Project
East West Rail (Western Section) Phase 2

Drawing Title
PASSING PLACE A3_P_7 GENERAL ARRANGEMENT

Stage 2 Road safety audit response report

Offline Highways Passing Places – Package 2 – Oxfordshire (A3 Marsh Gibbon – Compound Access)

PASSING PLACE A3_P_7 EXISTING UTILITIES AND SITE CLEARANCE

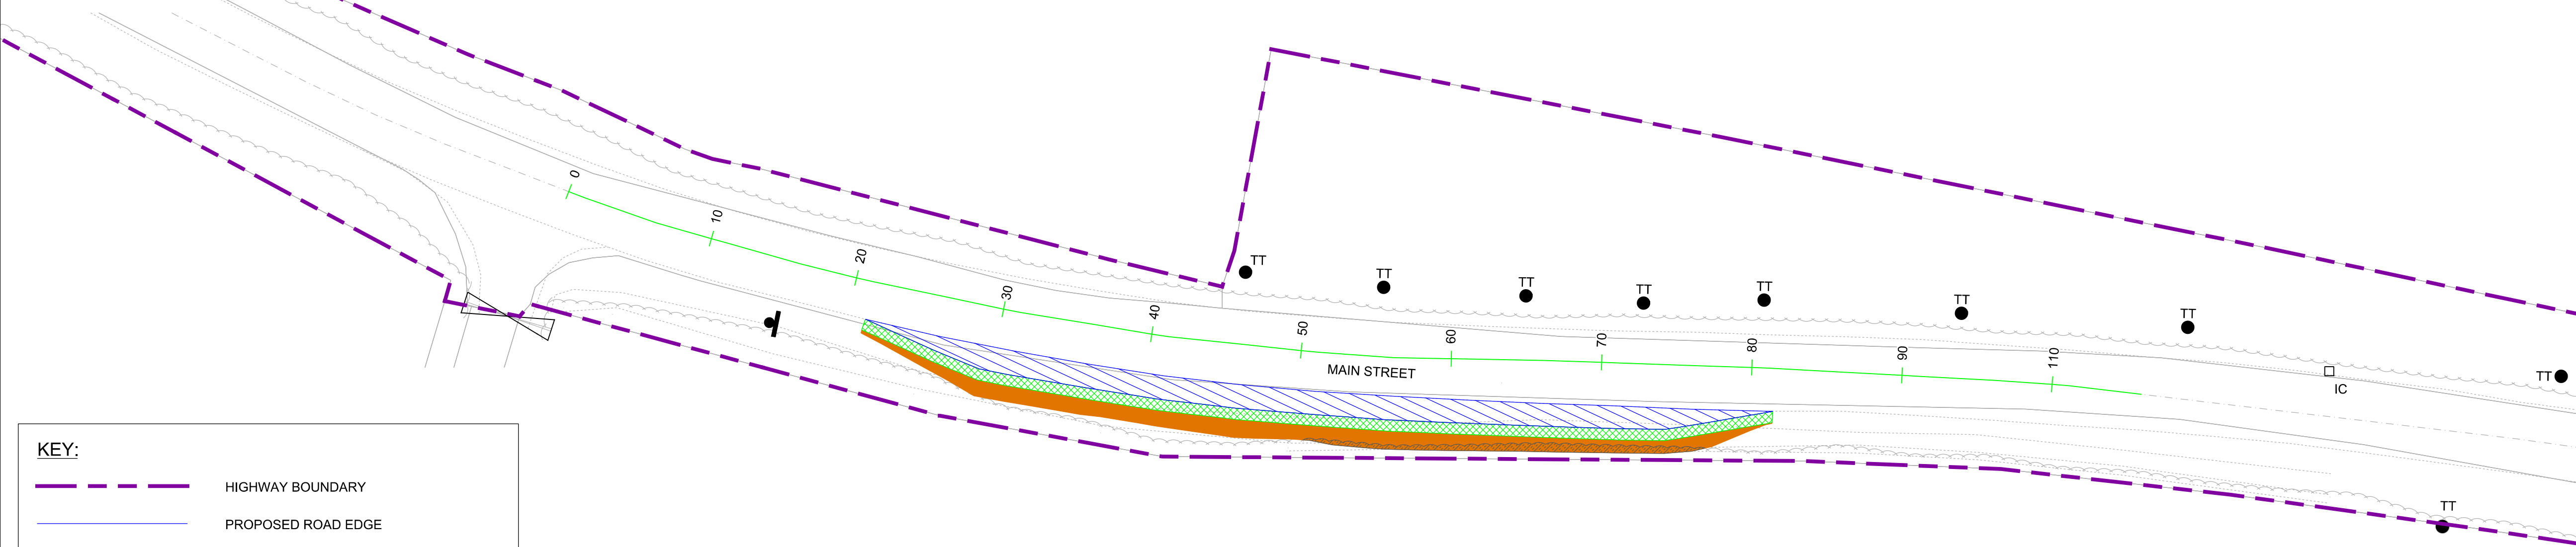
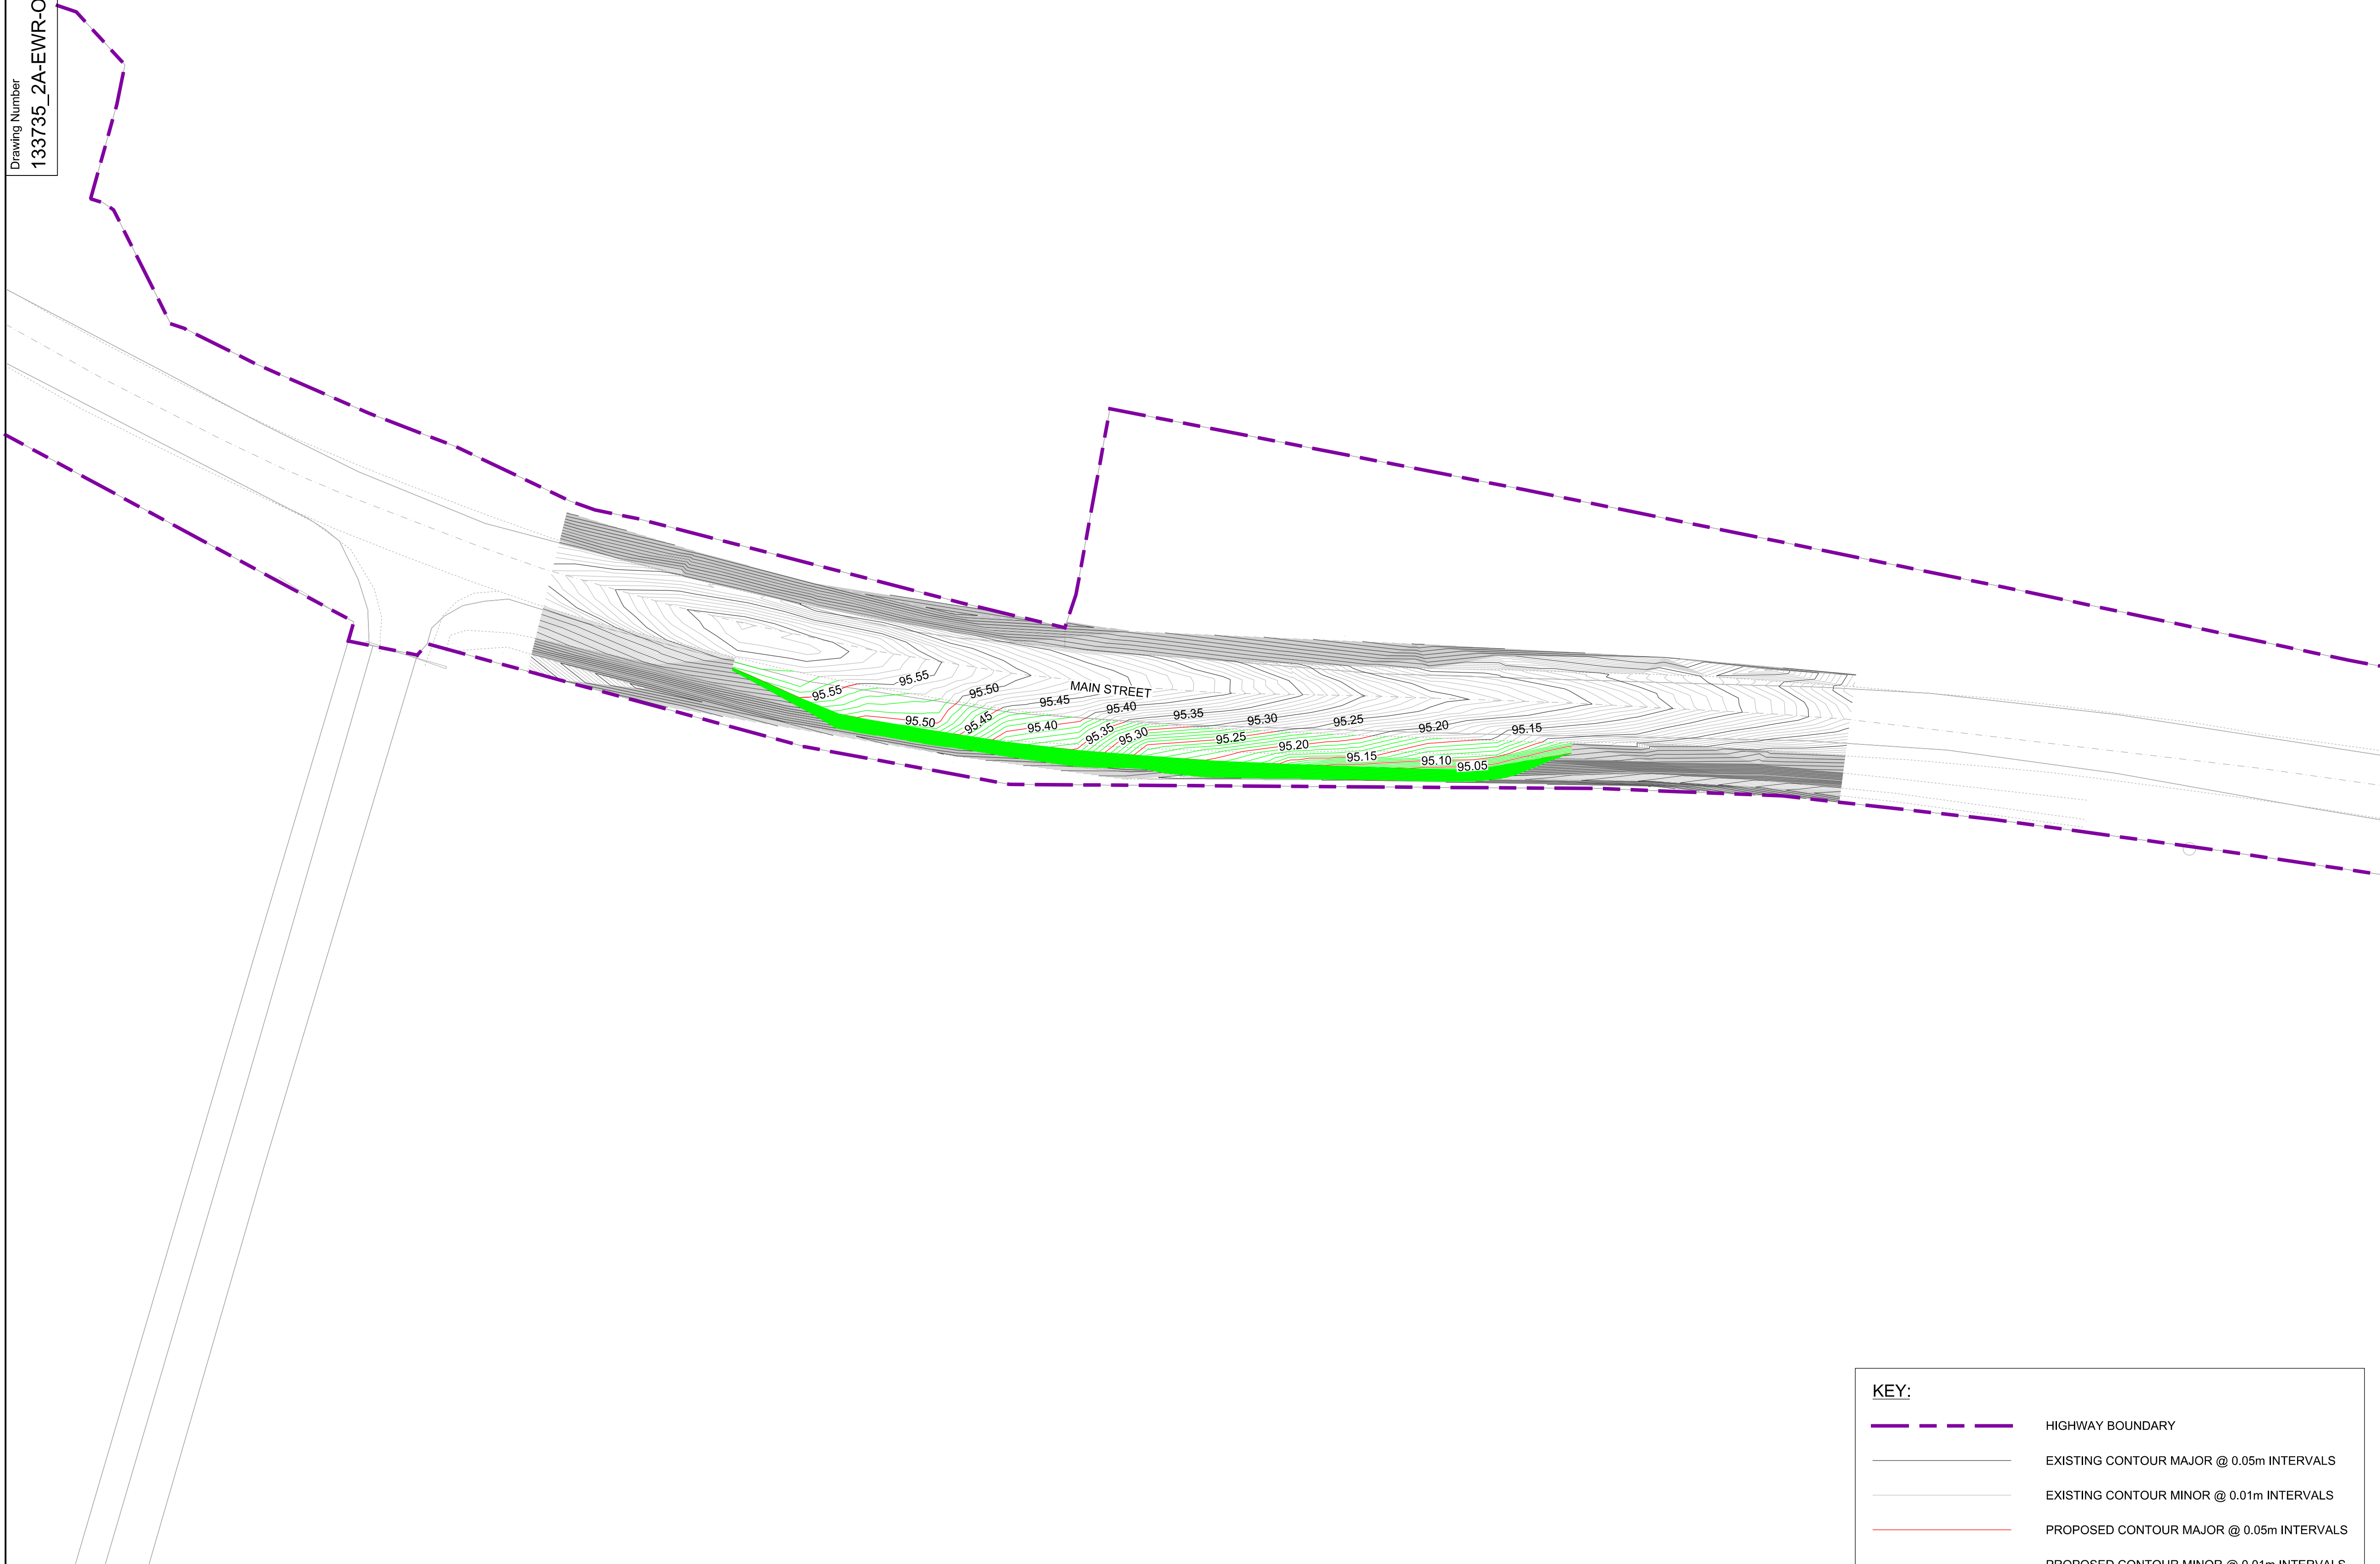
Location: Passing Places A2-P-2, A3-P-2, A3-P-3, A3-P-4, A3-P-5, A3-P-6, A3-P-7, A3-P-8, A3-P-9 and A3-P-10.

Passing places are proposed in positions where vegetation may restrict drivers' visibility of the route and the visibility of vehicles using the passing places. With this limitation, drivers of construction vehicles may not be aware that they should wait and might proceed, increasing the risk of side swipe collisions, or the risk of vehicles leaving the carriageway

There is further risk that existing vegetation will encroach into the carriageway increasing the risk of damage to vehicles and HGVs being pushed towards oncoming traffic.

2.5	<p>Passing Places A2-P-2, A3-P-2, A3-P-3, A3-P-4, A3-P-5, A3-P-6, A3-P-7, A3-P-8, A3-P-9 and A3-P-10. Unnamed Road (towards Mill Road) and Unnamed Road.</p>	<p>Driver visibility reduced by vegetation Passing places are proposed in positions where vegetation may restrict drivers' visibility of the route and the visibility of vehicles using the passing places. With this limitation, drivers of construction vehicles may not be aware that they should wait and might proceed, increasing the risk of side swipe collisions, or the risk of vehicles leaving the carriageway on narrower sections of carriageway. Additionally, drivers of approaching vehicles may not anticipate the construction vehicle leaving the passing place, leading to side swipe or head on collisions. There is further risk that existing vegetation will encroach into the carriageway increasing the risk of damage to vehicles and HGVs being pushed towards oncoming traffic.</p>	<p>The existing vegetation should be cut back to ensure clear visibility to all traffic signs and to keep the carriageway clear from obstructions.</p>	<p>Accept the RSA problem and recommendation made by the RSA team. The site clearance drawings include vegetation clearance to achieve required visibility and signage strategy drawings likewise include this provision.</p>	Accepted	Proceed as Design Team Response
